UNITED STATES PATENT AND TRADEMARK OFFICE

APPLICATION NO.	FILING DATE	FIRST NAMED INVENTOR	ATTORNEY DOCKET NO.	CONFIRMATION NO.
10/780,256	02/17/2004	Michael L. O'Banion	0275Y-625COC	3430

Office Action Summary	Application No. 10780,256	Applicant(s) O'BANION ET AL	
	Examiner Katherine W. Mitchell	Art Unit 3677

DETAILED ACTION

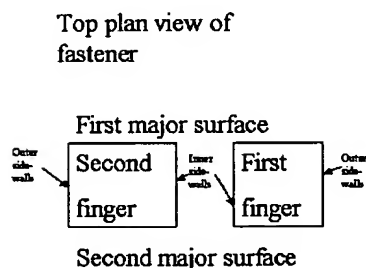
6. The drawings are objected to under 37 CFR 1.83(a) because they fail to show 50" as described in the specification para [0065] as appearing in Fig 11, or first set of teeth 40 as described for Fig 3 in paragraph [0055]. Also, Any structural detail that is essential for a proper understanding of the disclosed invention should be shown in the drawing. MPEP § 608.02(d). Corrected drawing sheets are required in reply to the Office action to avoid abandonment of the application. Any amended replacement drawing sheet should include all of the figures appearing on the immediate prior version of the sheet, even if only one figure is being amended. The figure or figure number of an amended drawing should not be labeled as "amended." If a drawing figure is to be canceled, the appropriate figure must be removed from the replacement sheet, and where necessary, the remaining figures must be renumbered and appropriate changes made to the brief description of the several views of the drawings for consistency. Additional replacement sheets may be necessary to show the renumbering of the

7. Examiner is assuming, based on an interview with attorney in related case 10/780072, that the major surfaces and sidewalls are arranged as below:

8. Fig 4 should be described as a front view, not a side view, if Fig 3 is a side view. Examiner assumed teeth not labeled are teeth 40.

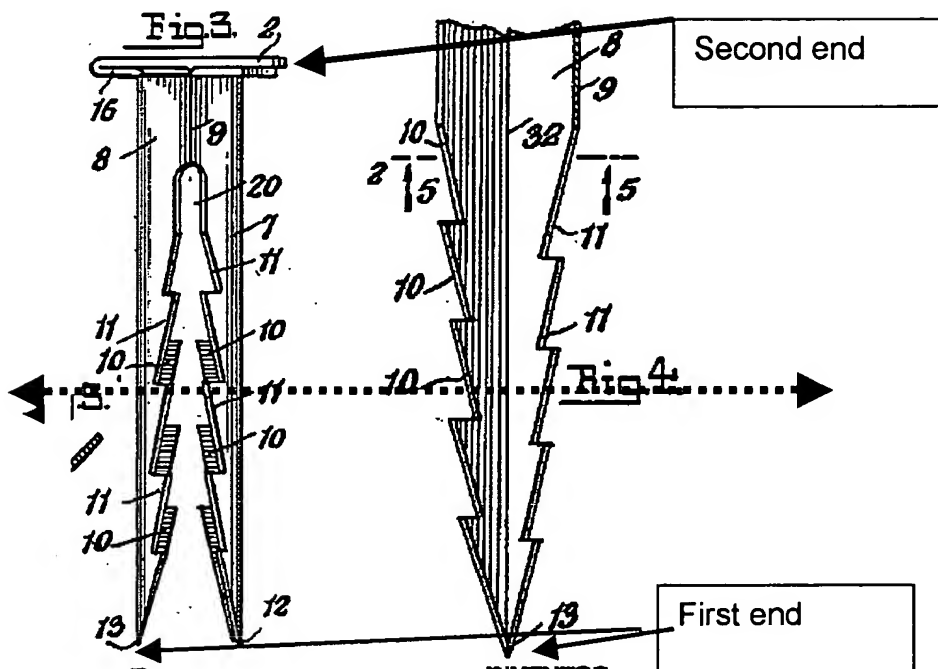
Re claim 85: Gisoni teaches in Figs 1-4 and col 2 lines 29-65 a nail capable of fastening framing members together comprising:

- a first end (13) configured to pierce framing members
- a second end (2) configured to receive a driving force
- a stem (8) extending between first and second ends, having an interior surface (concave interior –shown in Fig 4) and exterior surface (concave exterior shown on left in Fig 3) separated by 1st and 2nd edges (thickness of metal forming “11” and “10” respectively in Fig 4)
- a 1st set of teeth 11 extending axially along a portion of first edge
- a 2nd set of teeth 10 extending axially along a portion of second edge (see also col 2 lines 29-65)

Re claim 86: Fig 3 shows the lip (projecting past stem 8 at 16) which is capable of engaging a framing member

Re claim 87: Fig 3 shows each tooth having a radially extending surface

substantially parallel to said lip (flat upper edge of tooth) (all parallel to dotted line drawn in by examiner)

Re claim 88: Figs 3 and 4 show each tooth axially staggered relative to one another.

Re claim 89: Figs 3 and 4 show the lower portion of the stem reducing in cross section as the stem extends toward the first end. Note – examiner is defining cross section as viewed “cut” by examiner’s dotted line in Fig 3 and 4.

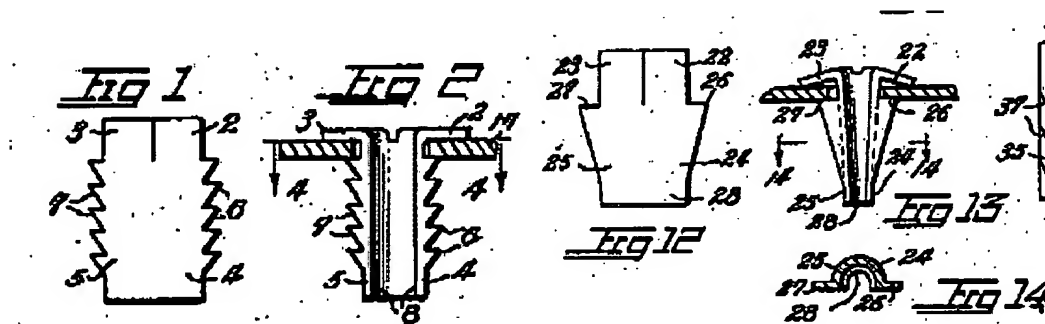
Re claims 97-98: Fig 4 shows 1st and 2nd edges at 9 (above cut line 5 in Fig 4)

as substantially parallel to each other. That same Figure 4 shows 1st and 2nd edges angled relative to one another (see for example, comparing both surfaces 10 to both surfaces 11 labeled in Fig 4.) {Applicant has not specified exactly how the edges must be parallel. For example, / and \ are parallel in that their "top face" lies in the same plane – i.e, they are on the plate of the paper. However, their orientation relative to the longitudinal axis of the paper is not parallel.}
